# QUEANBEYAN-PALERANG REGIONAL COUNCIL

- ITEM 4.1            DETERMINATION REPORT - REVIEW OF ENVIRONMENTAL  
FACTORS - SOUTH JERRABOMBERRA WATER AND  
SEWER INFRASTRUCTURE
- ATTACHMENT 2    REVIEW OF ENVIRONMENTAL FACTORS - SOUTH  
JERRABOMBERRA WATER AND SEWER  
INFRASTRUCTURE - CONDITIONS

## Review of Environmental Factors – South Jerrabomberra Water and Sewer Infrastructure

### Proposed Determination Conditions

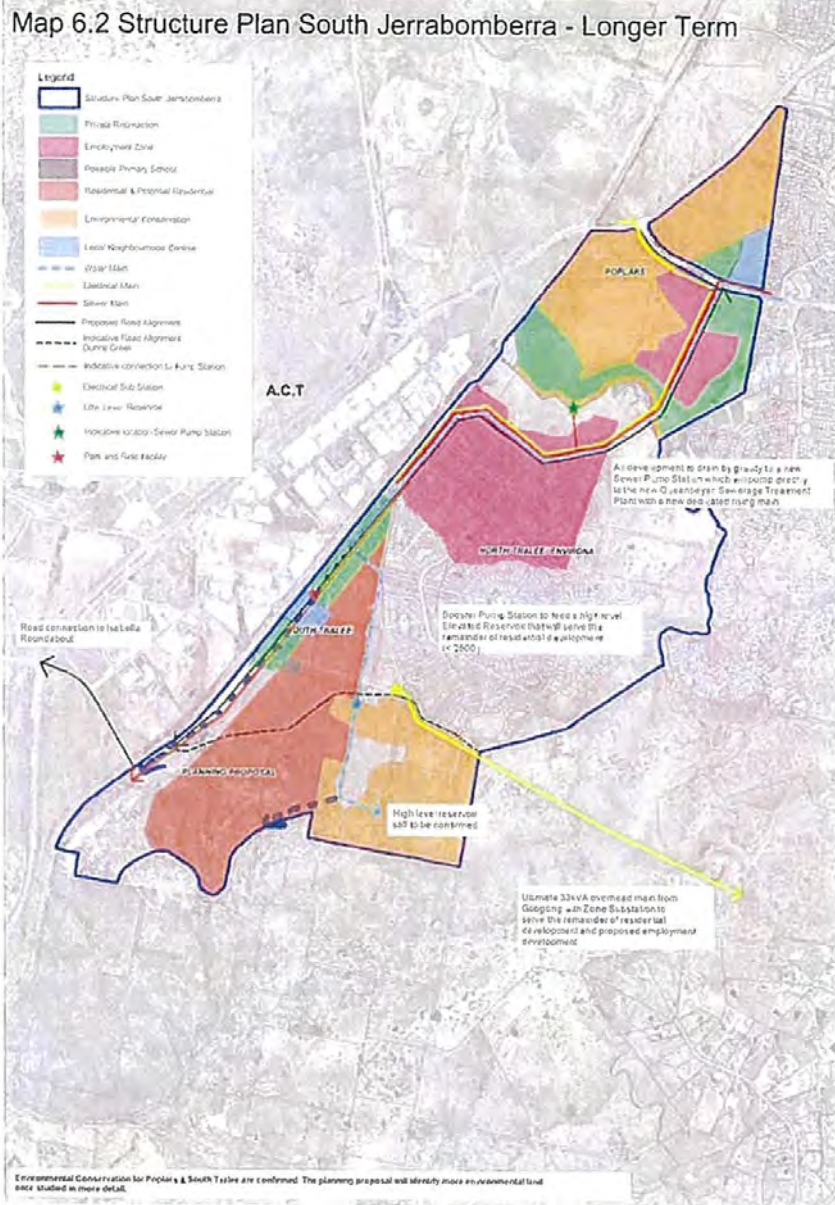
- Map 6.2 within Appendix B indicates that the Water Supply Main will end within the Forest Morrison Portion of landownership. It is requested that this diagram be amended to end at the boundary of Tralee Station.

- A diagram is attached as an appendix to this submission.
- We recommend that a timeline be incorporated within an updated agreement to service the southern portion of South Jerrabomberra.

It is recommended that Council consider the implementation and delivery of services for the whole of South Jerrabomberra, which will allow the efficient and orderly development.
